RIVERMONT PRECINCT 2
STAGE 1 - 17 LOTS

DRAWING INDEX

PLANS AND DOCUMENTS
referred to in the PDA
DEVELOPMENT APPROVAL

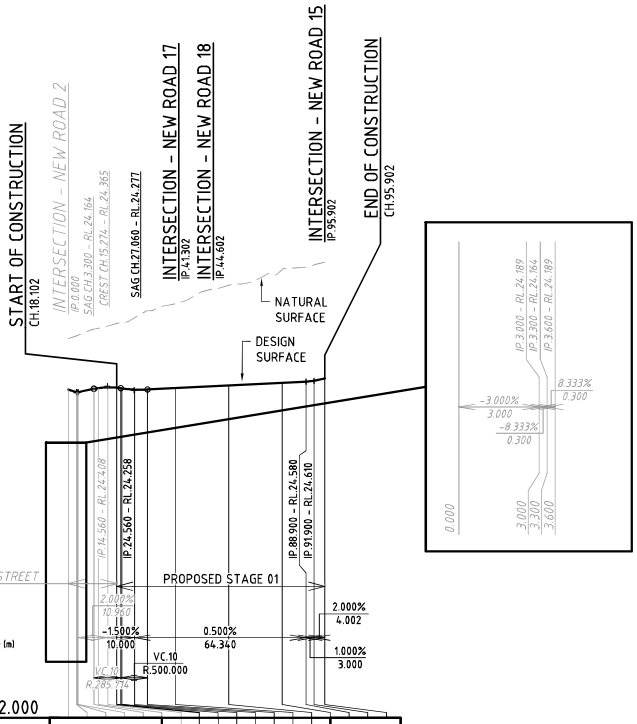
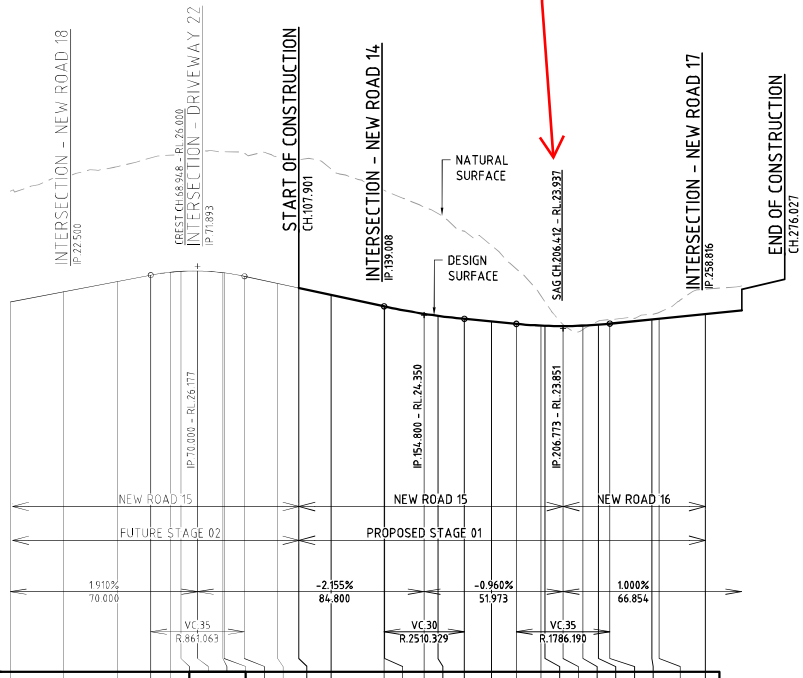
Ensure sag point coincides with sag gully pit location, to be confirmed as part of CPM.

Drawing Title: STORMWATER CATCHMENT PLAN

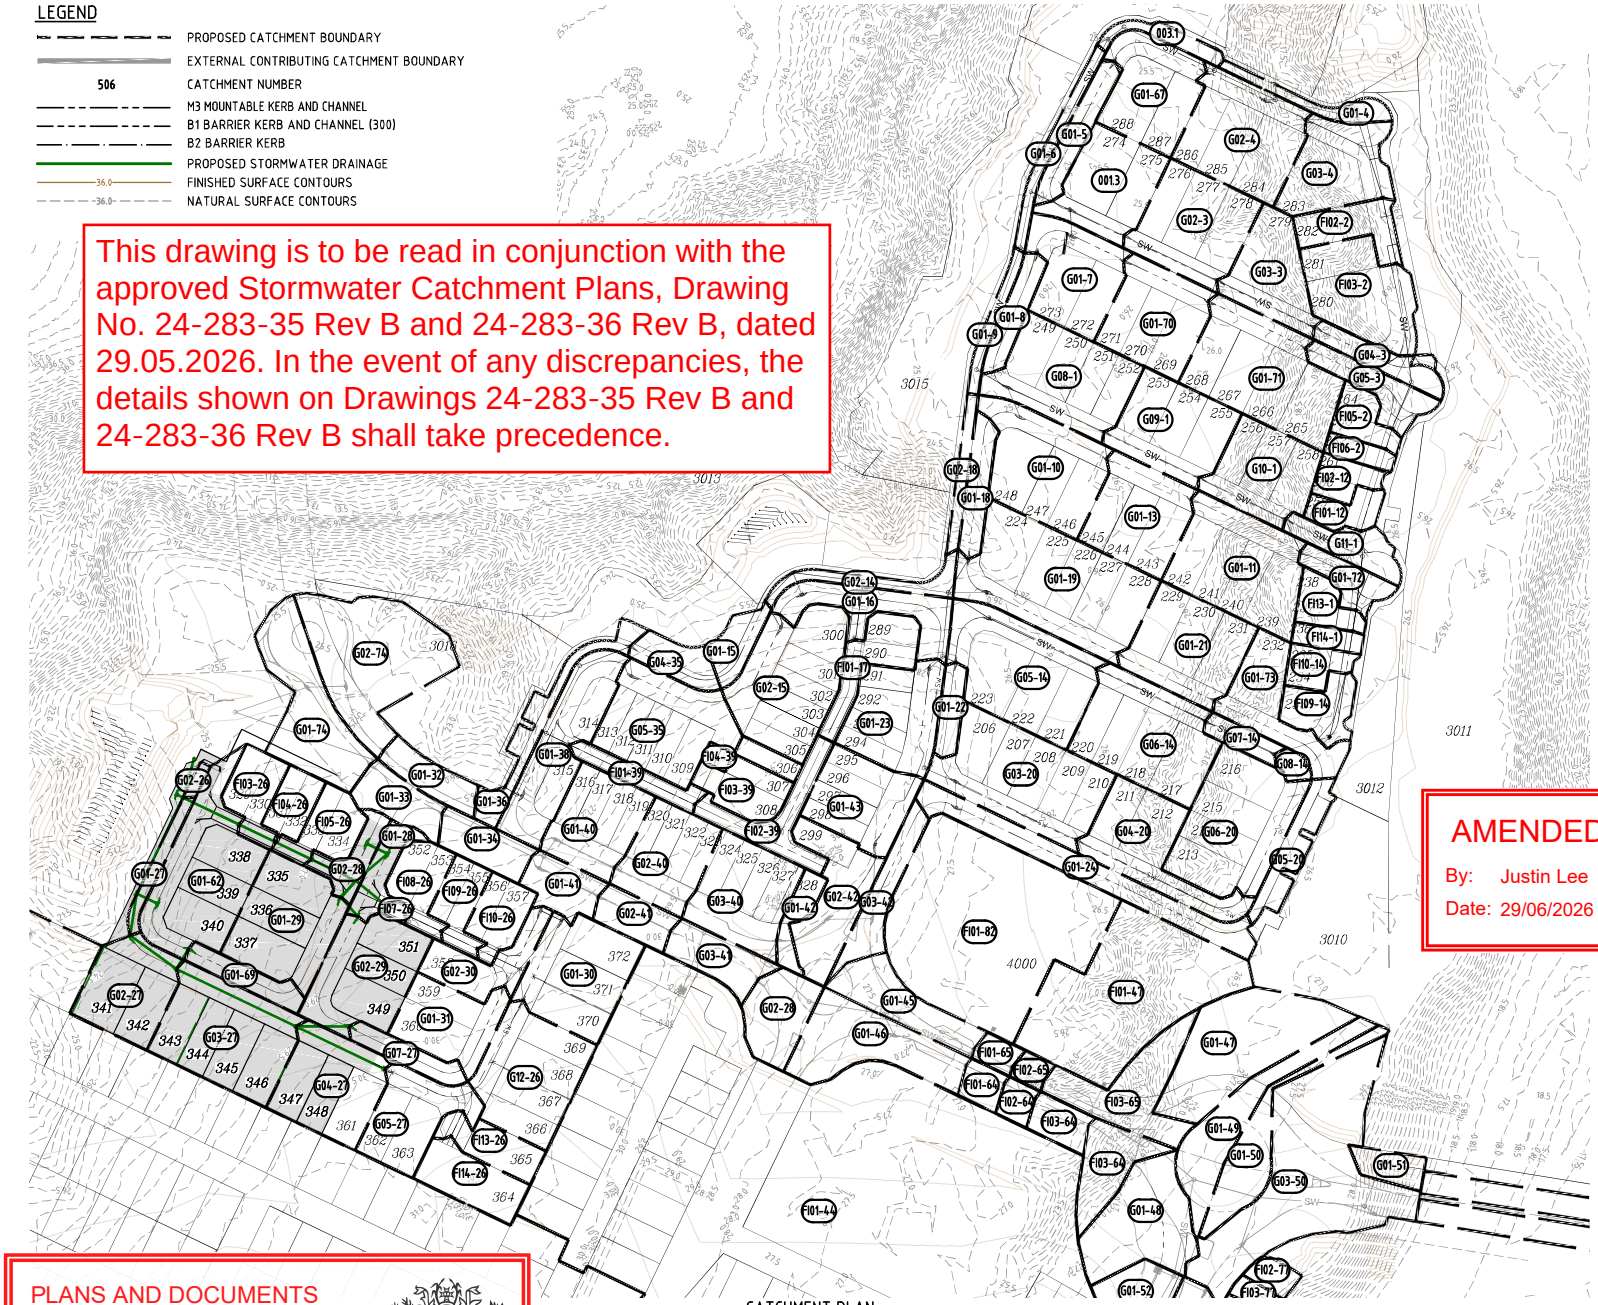
AMENDED IN RED

This drawing is to be read in conjunction with the approved Stormwater Catchment Table, Drawing No. 24-283-37 Rev B, dated 29.05.2026. In the event of any discrepancies, the details shown on Drawing 24-283-37 Rev B shall take precedence.

Drawing Title: STORMWATER LONG SECTIONS SHEET 2

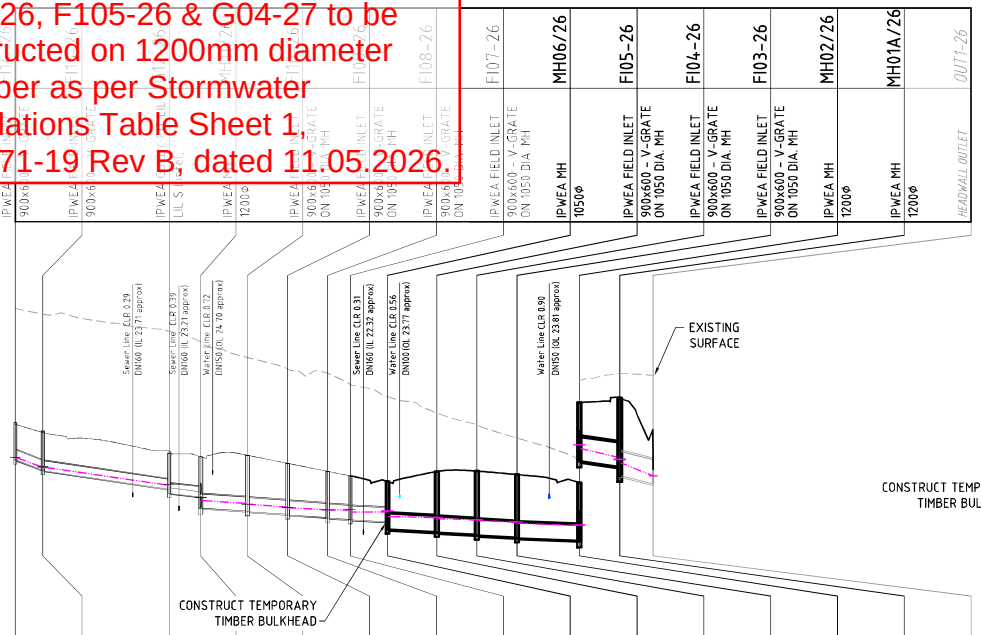
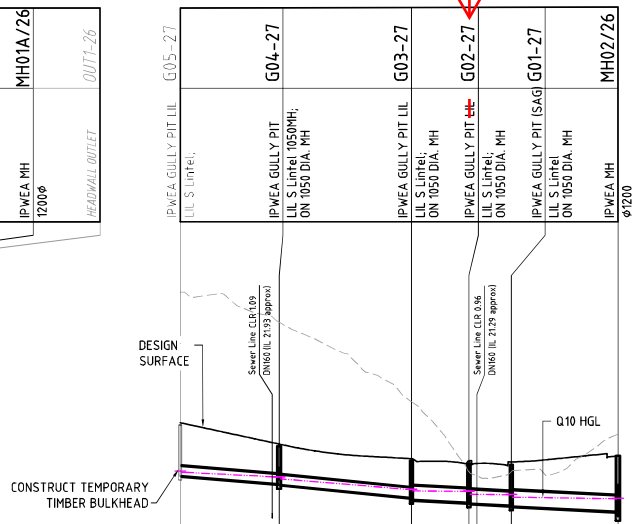
Stormwater structures F103-26, F104-26, F105-26 & G04-27 to be constructed on 1200mm diameter chamber as per Stormwater Calculations Table Sheet 1, #24-271-19 Rev B, dated 11.05.2026.

G0-2-27 to be provided as an IPWEA sag gully pit.

F1512 CONTRACTOR TO PROVIDE FORM 15 AND 12 FOR ALL MAINTENANCE HOLES GREATER THAN 3m DEPTH.

LAYOUT PLAN
SCALE 1:500

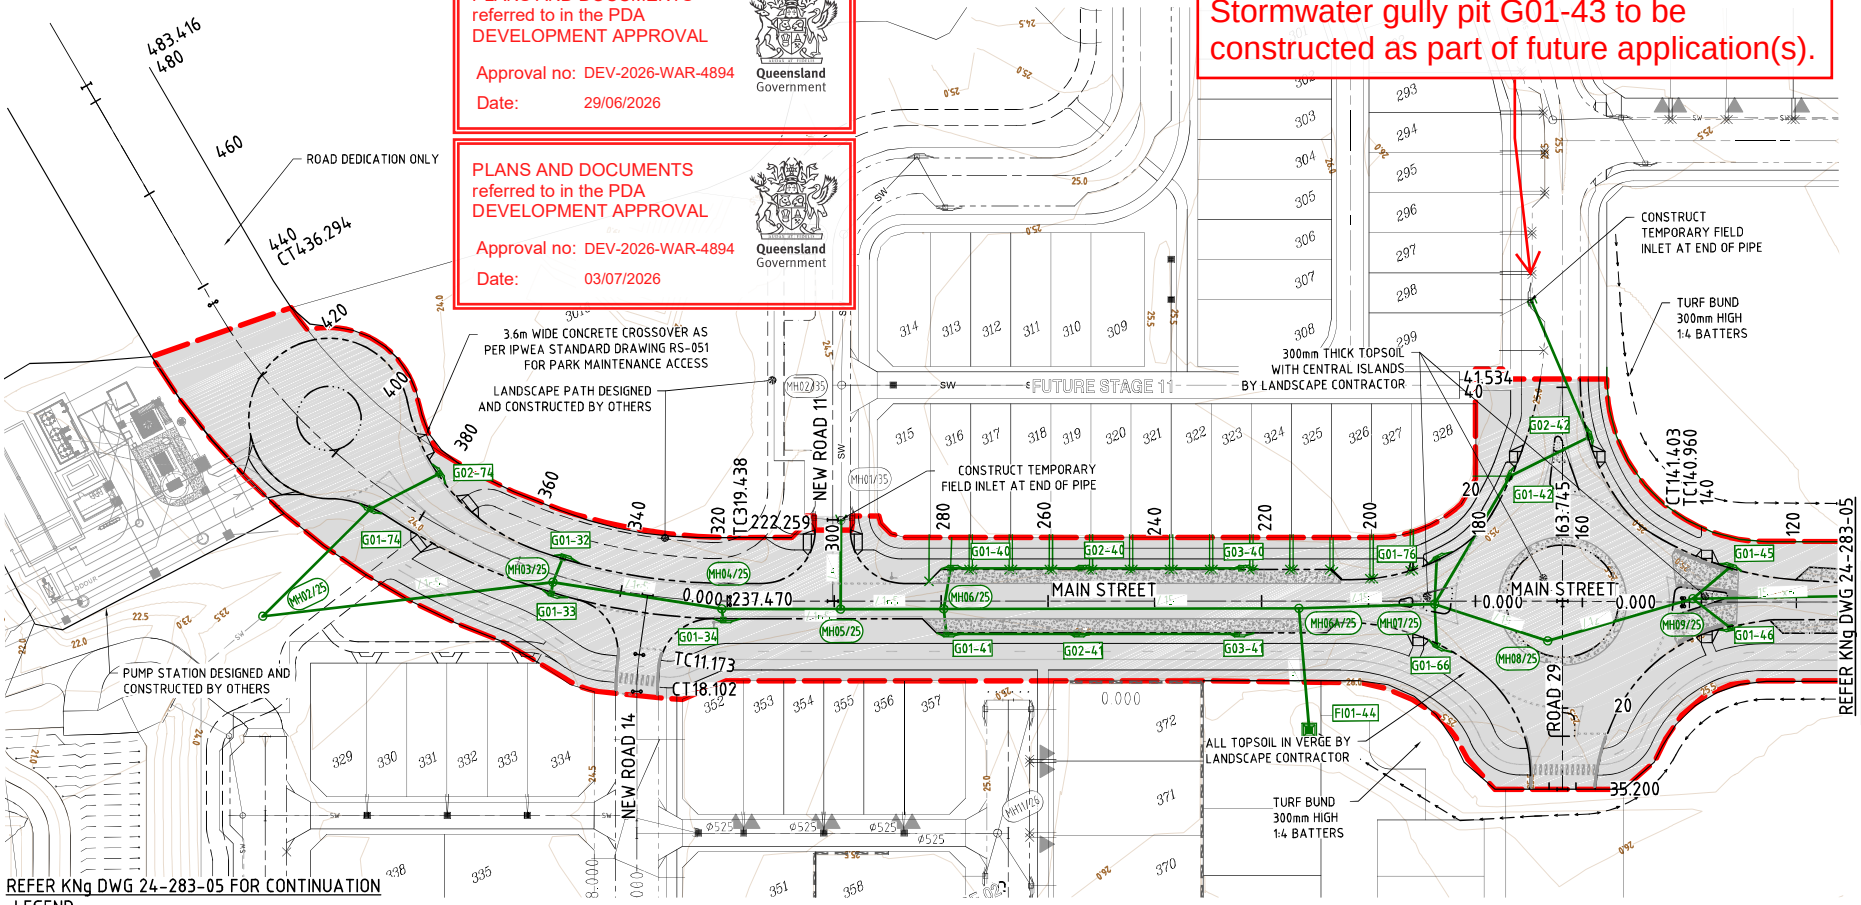
Stormwater gully pit G01-43 to be constructed as part of future application(s).

Drawing Title: GENERAL STORMWATER PLAN SHEET 2

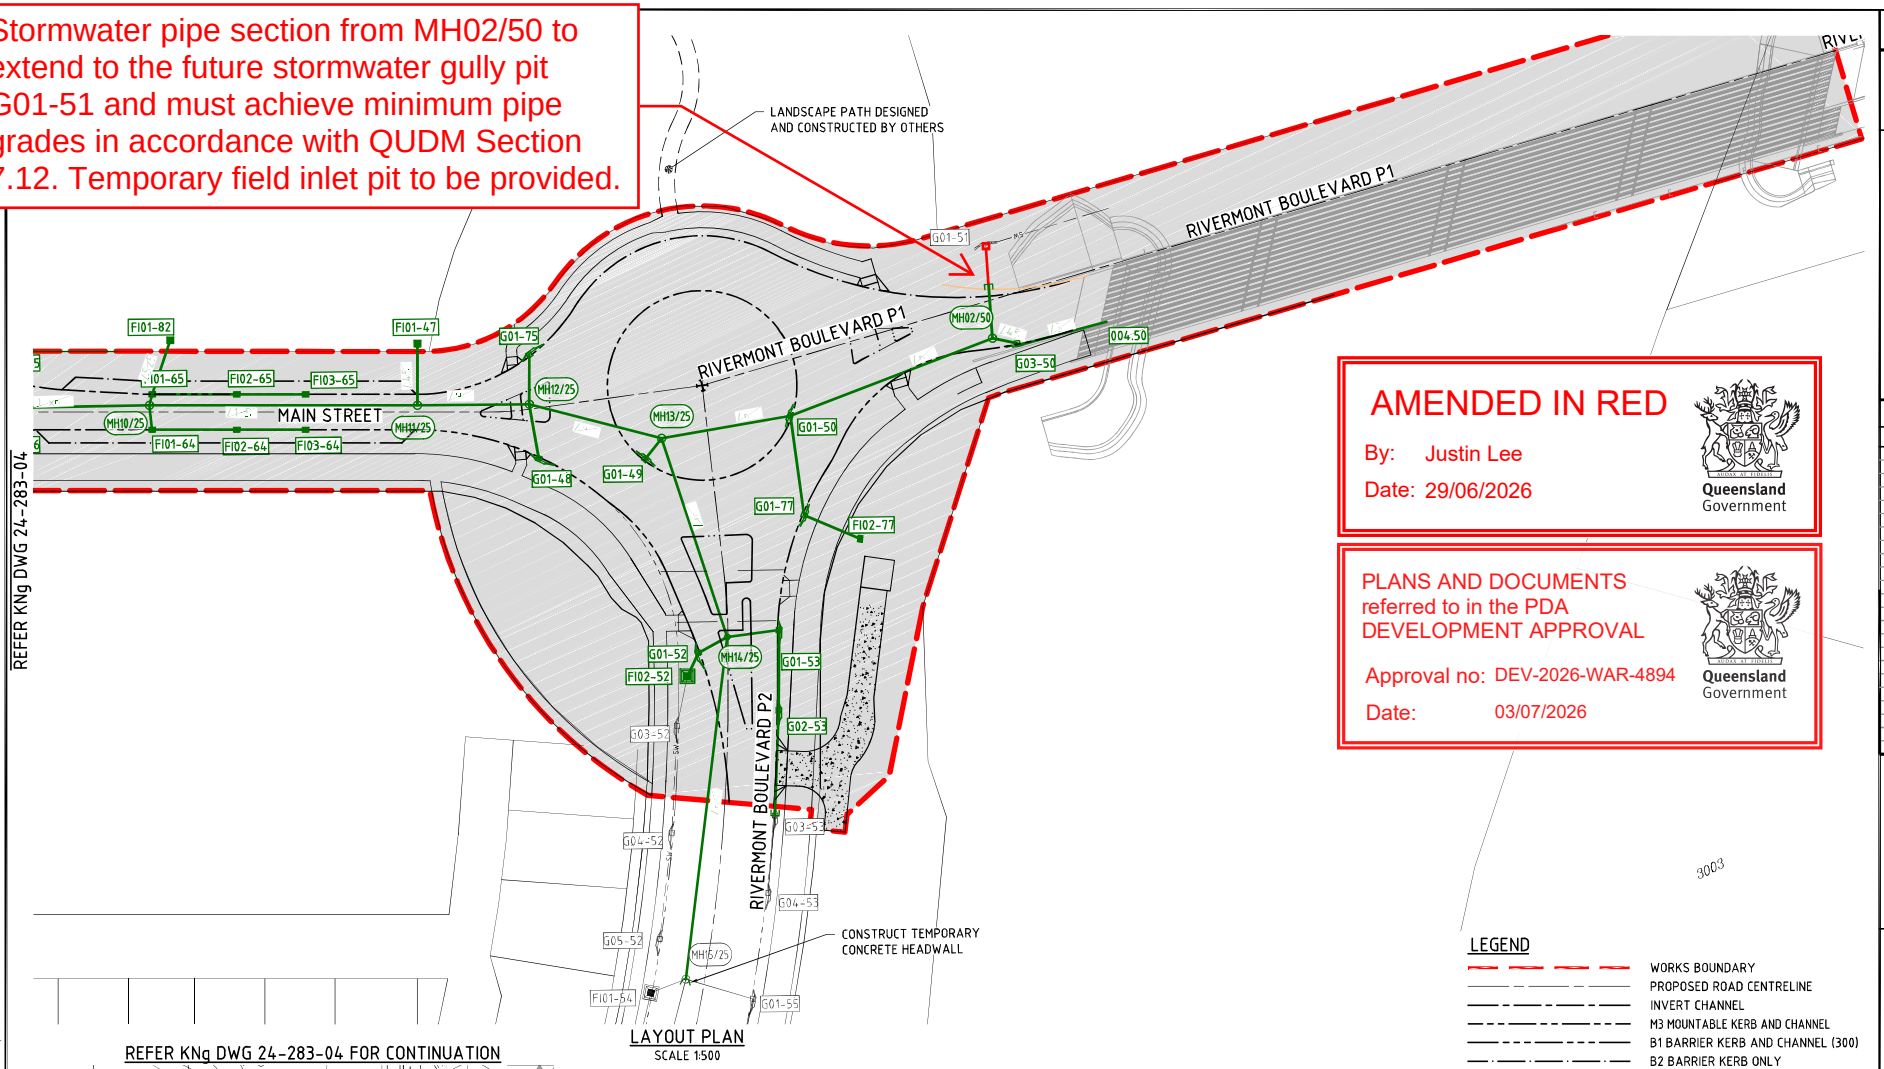
Stormwater pipe section from MH02/50 to extend to the future stormwater gully pit G01-51 and must achieve minimum pipe grades in accordance with QUDM Section 7.12. Temporary field inlet pit to be provided.

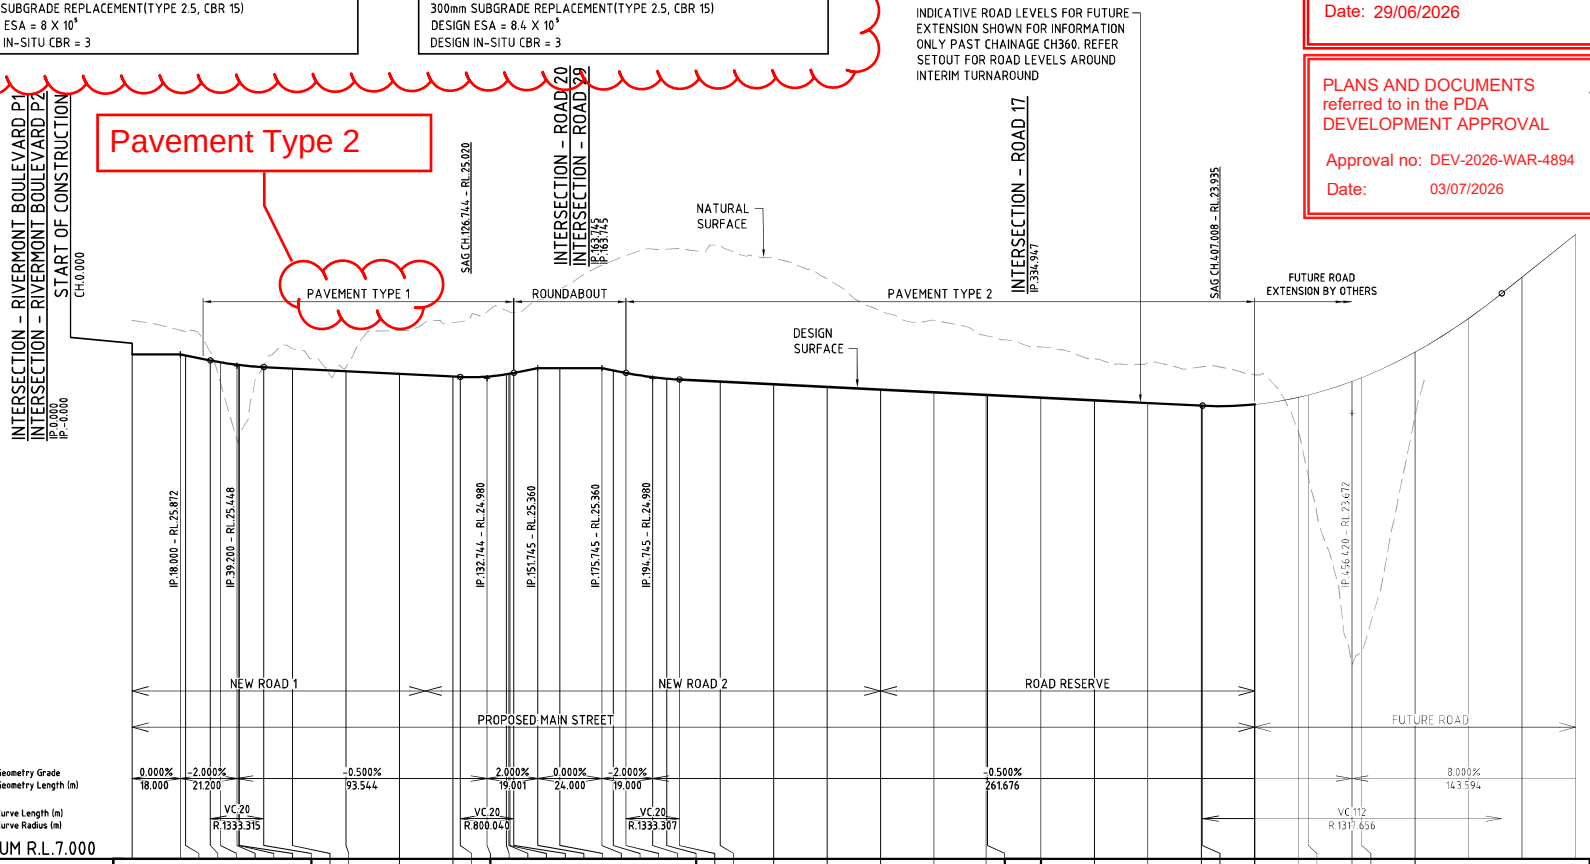
INDICATIVE ROAD LEVELS FOR FUTURE EXTENSION SHOWN FOR INFORMATION ONLY PAST CHAINAGE CH360. REFER SETOUT FOR ROAD LEVELS AROUND INTERIM TURNAROUND

Drawing Title
ROADWORKS
LONGITUDINAL SECTION
ROAD 20

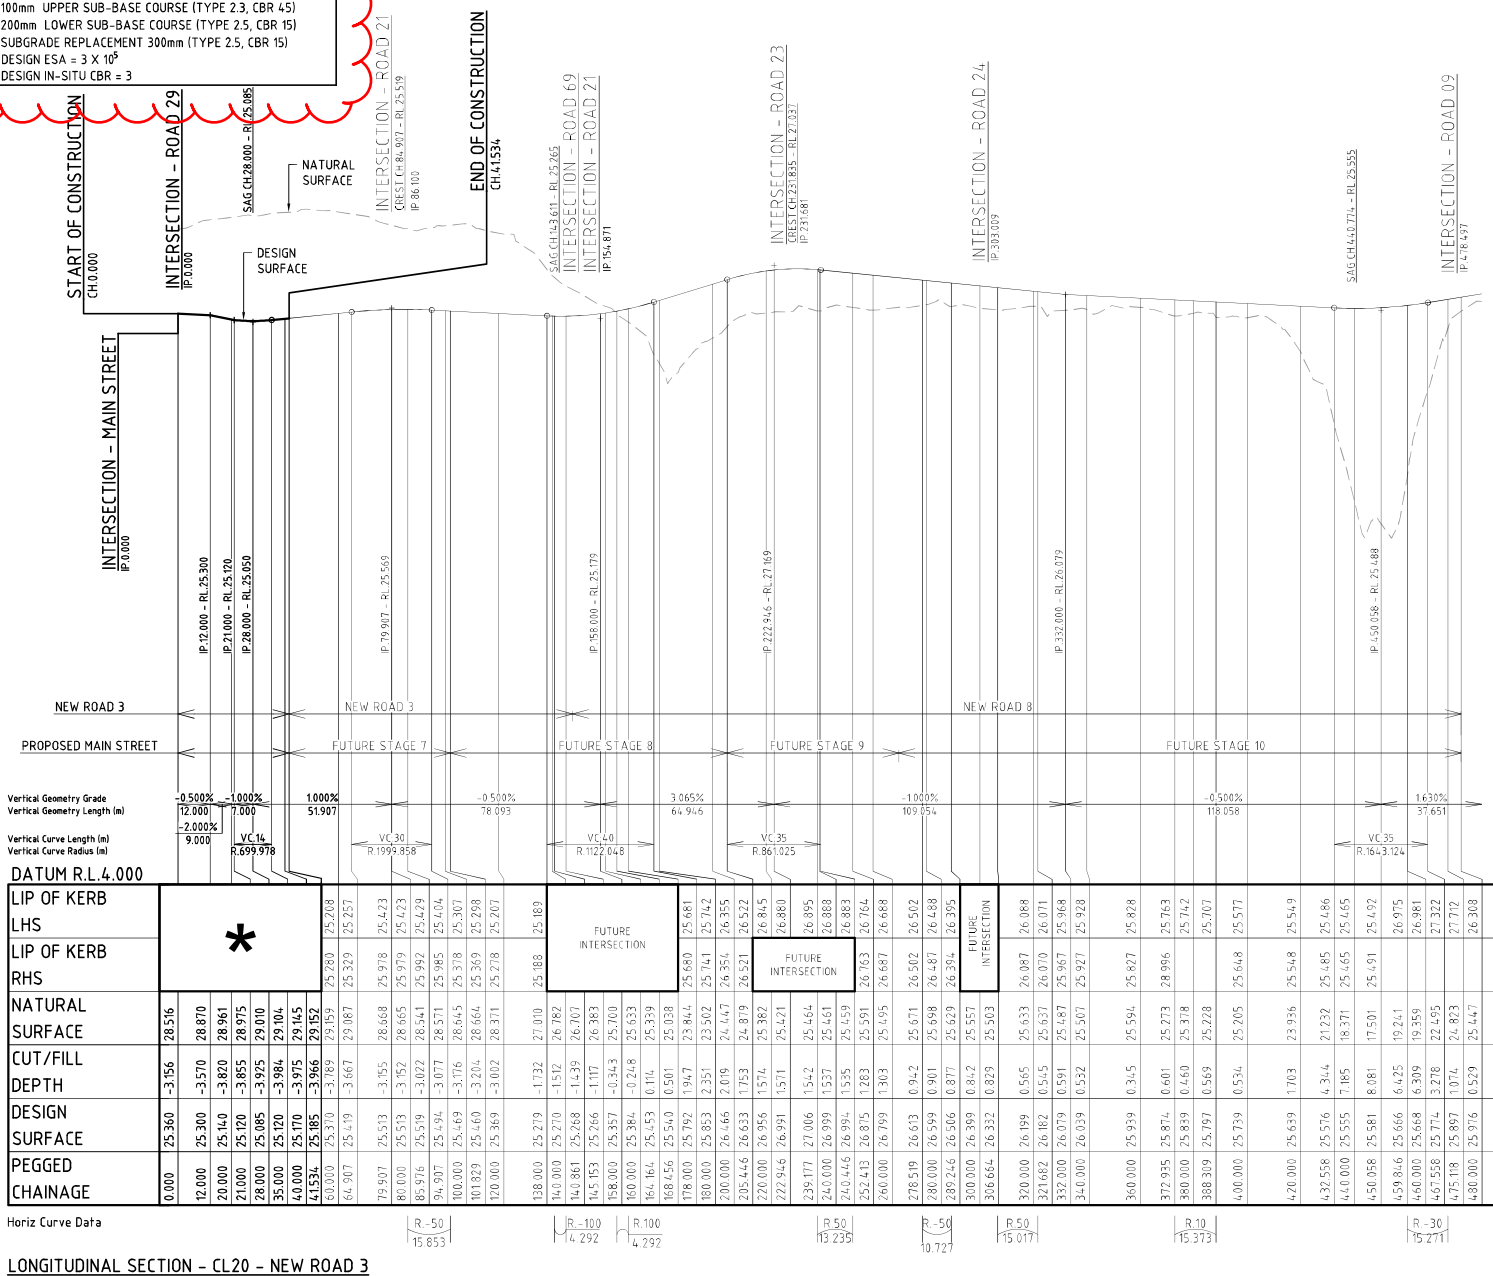
Refer to pavement design condition.
